Revision	Description	Date
A	Initial Release	?
B	As built changes: E990211-00-C	5/99
C	1. Added compensation networks to coil drivers with capacitors, Cadd1 through Cadd10 and resistors Radd1 through Radd5 2. Changed coil driver 183 ohm (R202, R216, R229, R243, R256) to 125 ohm, 2 Watt for ITMX and ITMY and to 183 ohm 1 watt on all other chassis. 3. Cadd1 through Cadd14 added to board to stabilize and limit high freq gain of 1Hz zero, 40Hz pole compensation stage. 4. Dadd1 through Dadd20 added to coil driver for op amp input protection.	2/00
D	Added Radd6, Radd7, Radd8, Radd9 to terminate unused inputs of MAX333 switches per E010178-00.	5/99

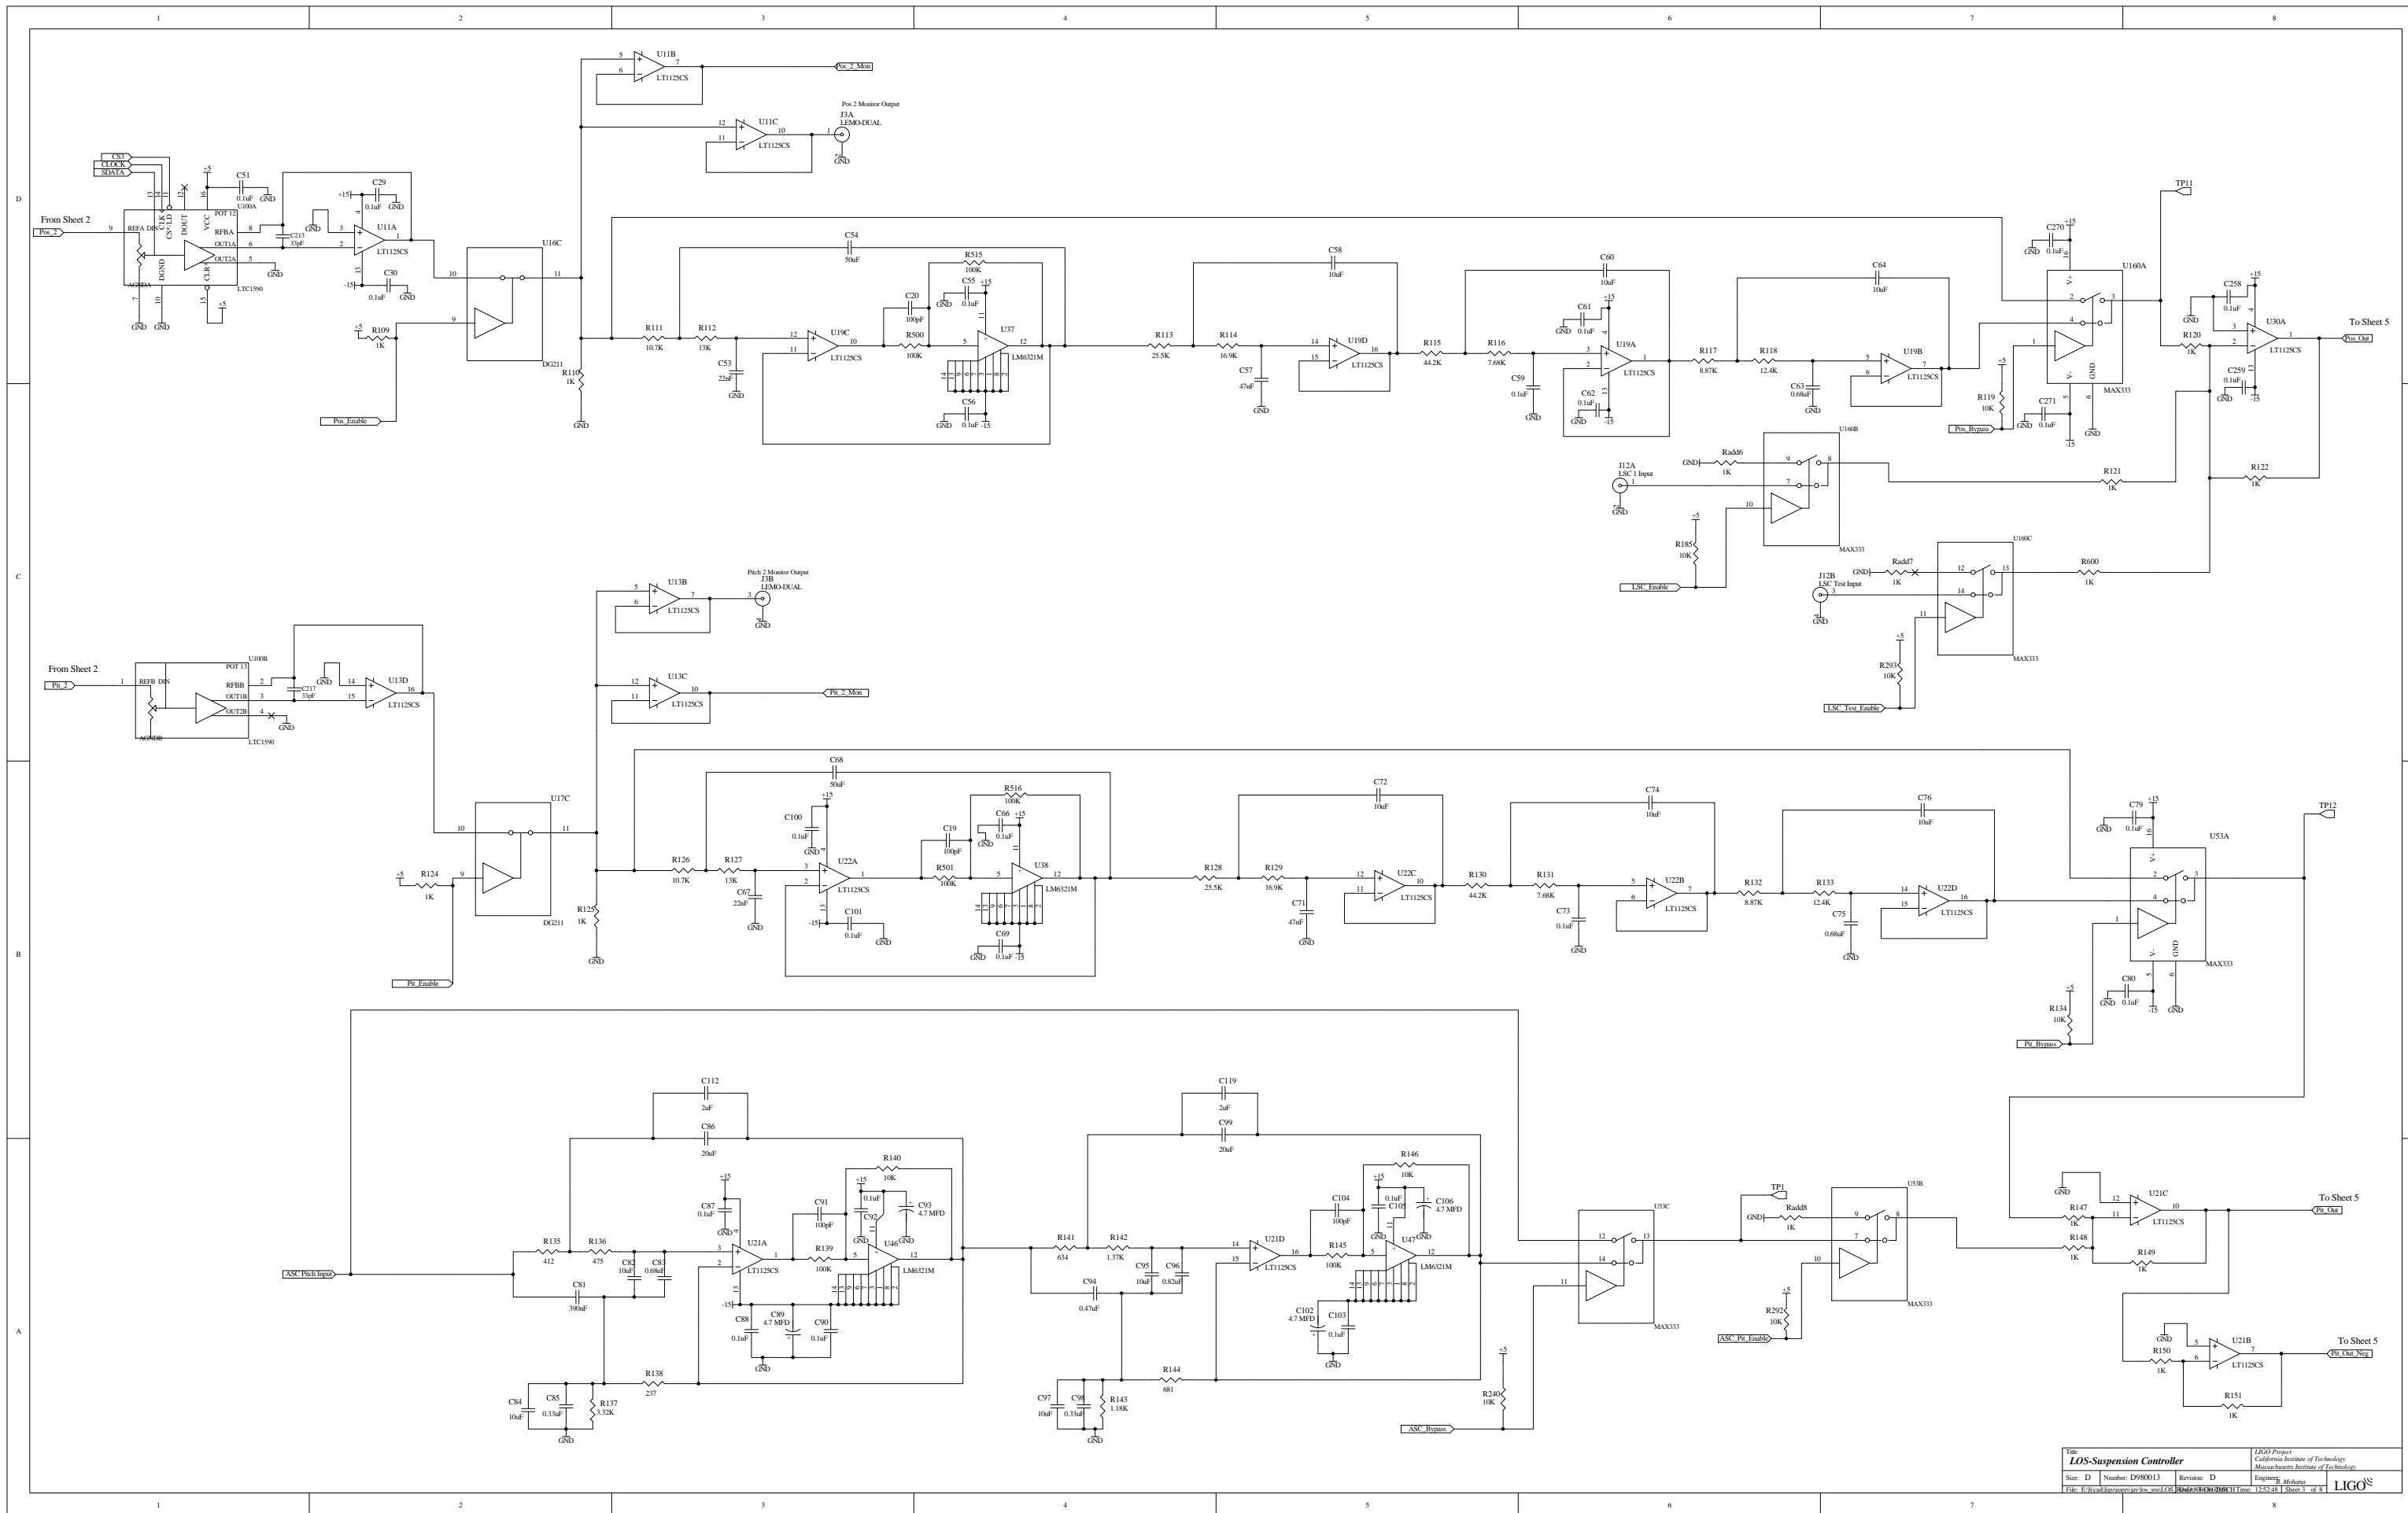
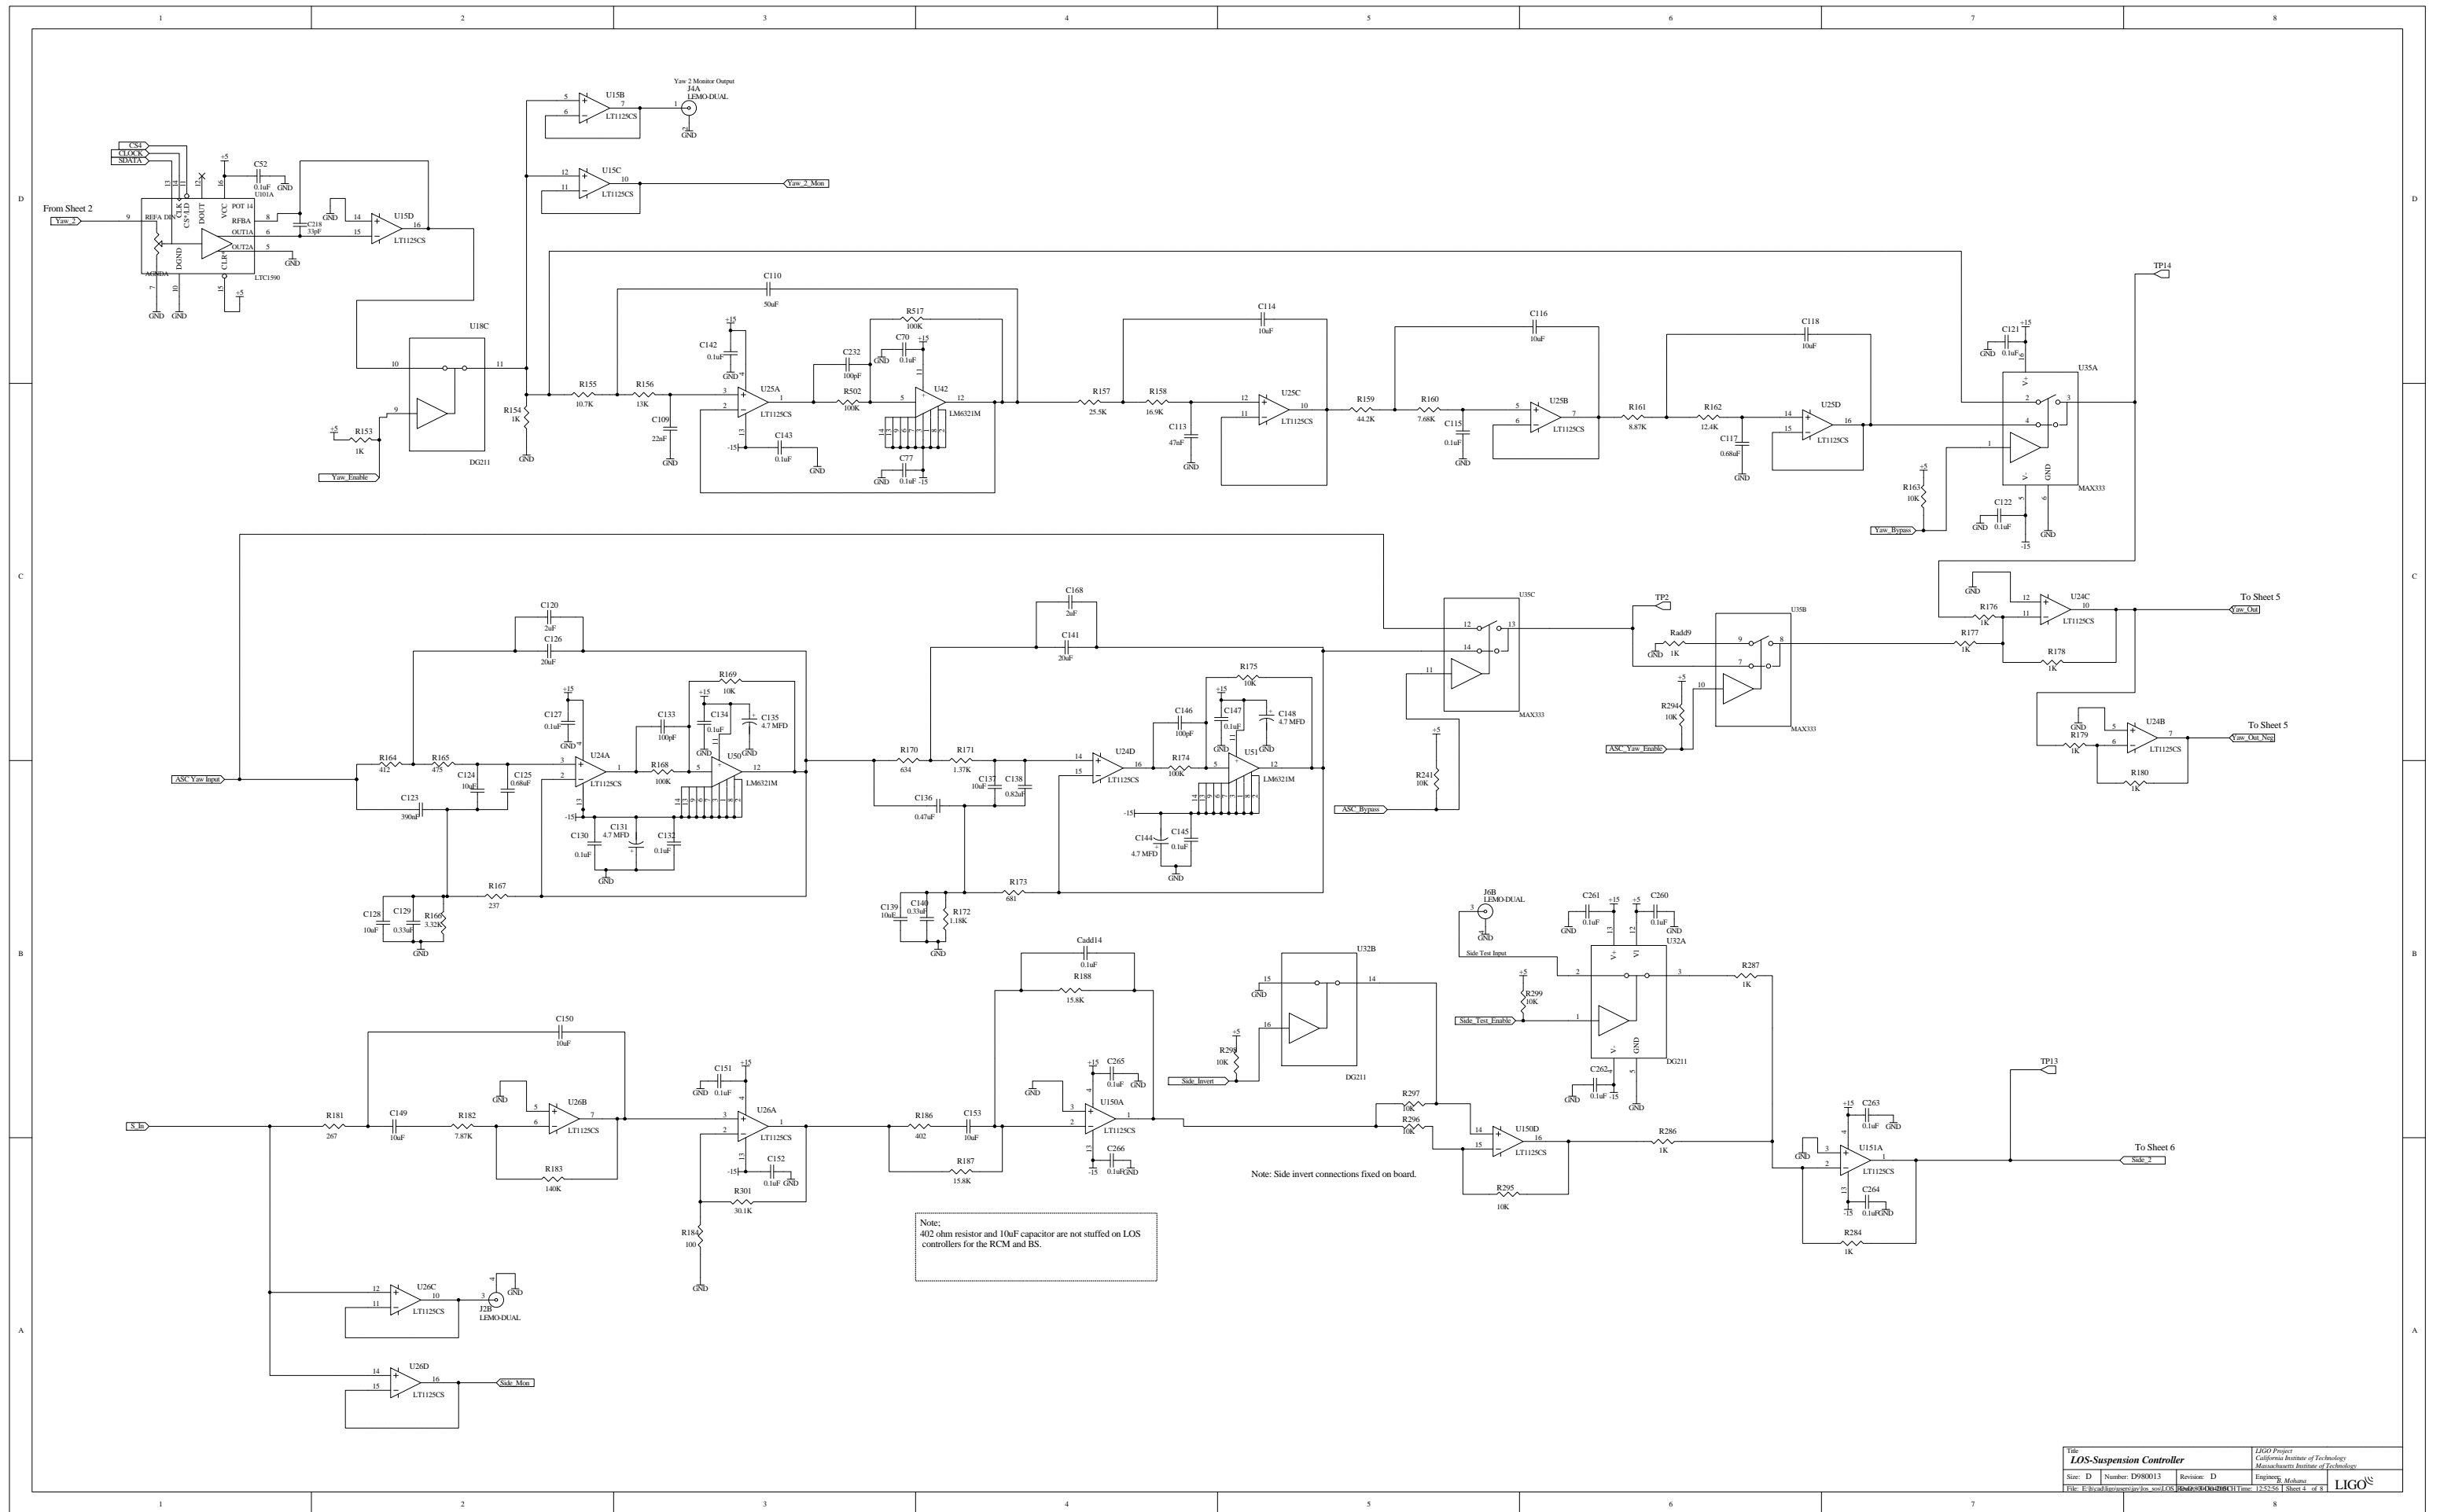
Note: PA85 feedback Cap and resistor added on bottom of the board

Note:
The wiring to the daughter card was changed after board manufacture. The actual connections to the board are made via wires to the coil driver outputs. The PD connections remain as shown.
An interface board (ref. D990022) is used for this function.
